SITE ADDRESS: St Catherines Place Shopping Centre East Street Bedminster Bristol

APPLICATION NO: 13/05616/P Outline Planning

RECOMMENDATION: Refuse

22/09/14 08:14 Committee report

Site Elevation - East

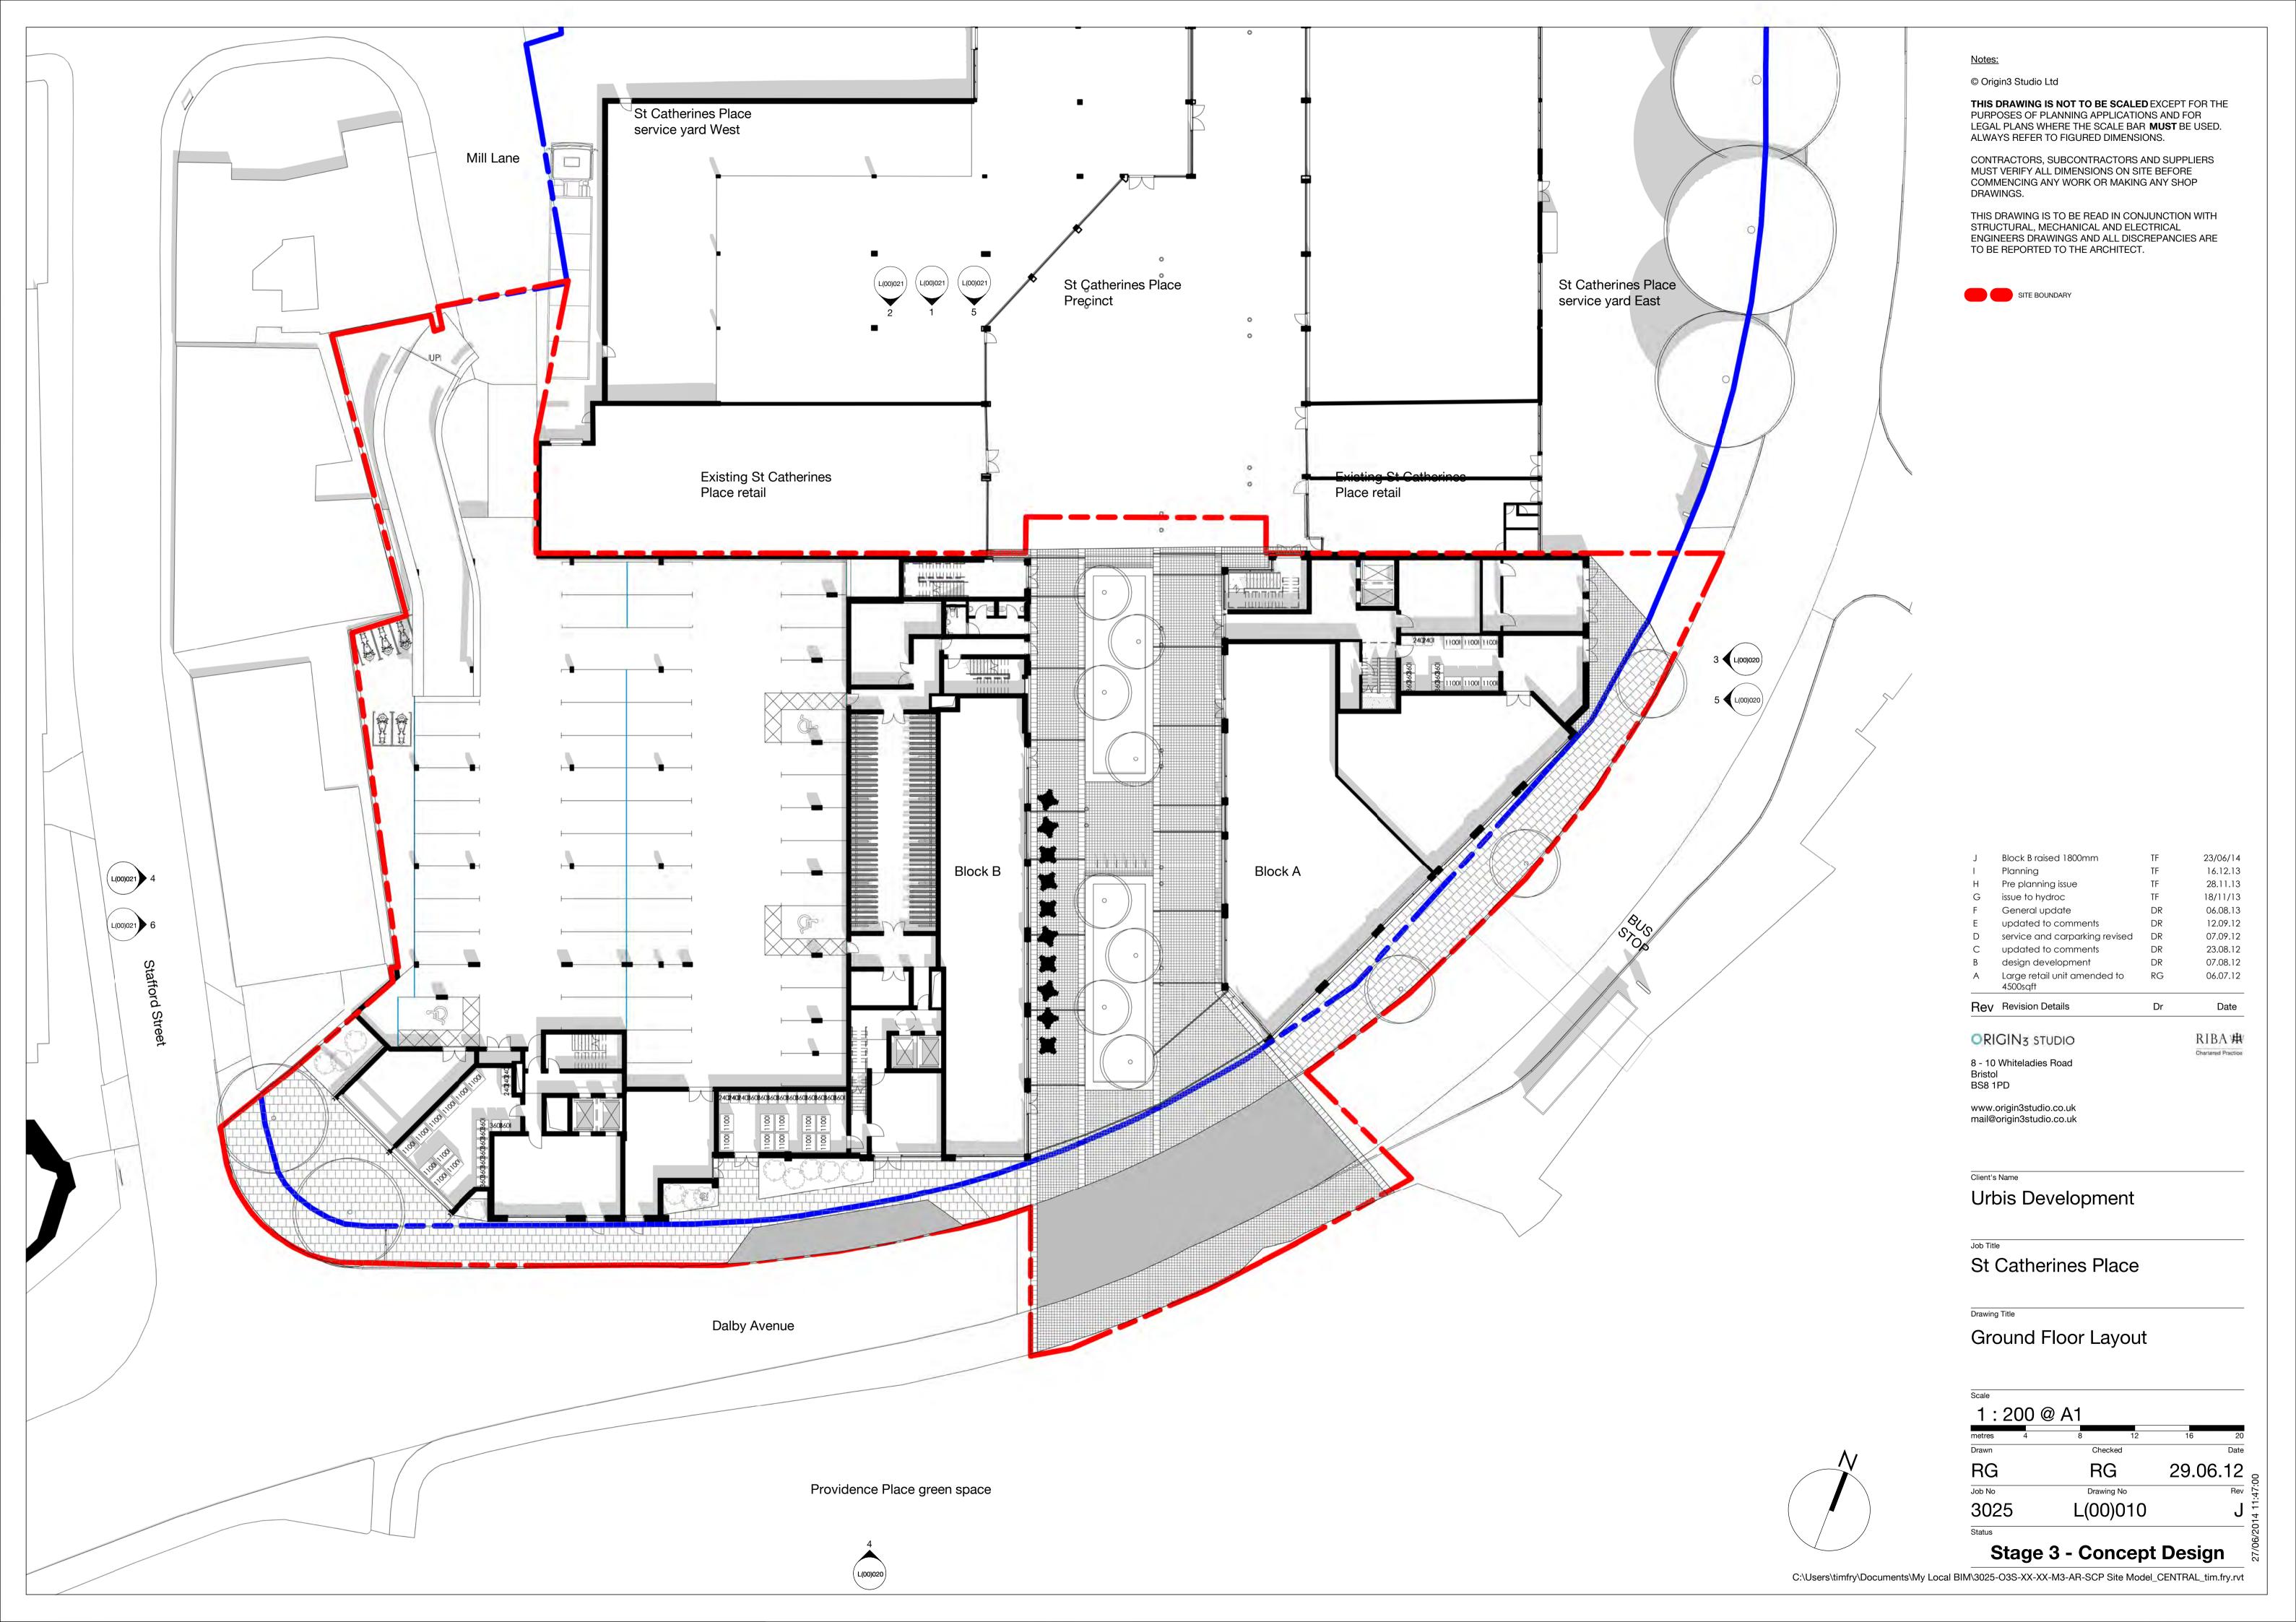
The revisions submitted by the applicant to address archaeological issues raises the building by 1.8m higher. In the context of a 16 storey building previously submitted, this does not change the impacts of the proposal which still continue to harm the townscape setting and character of the conservation area due to its excessive scale height and mass.
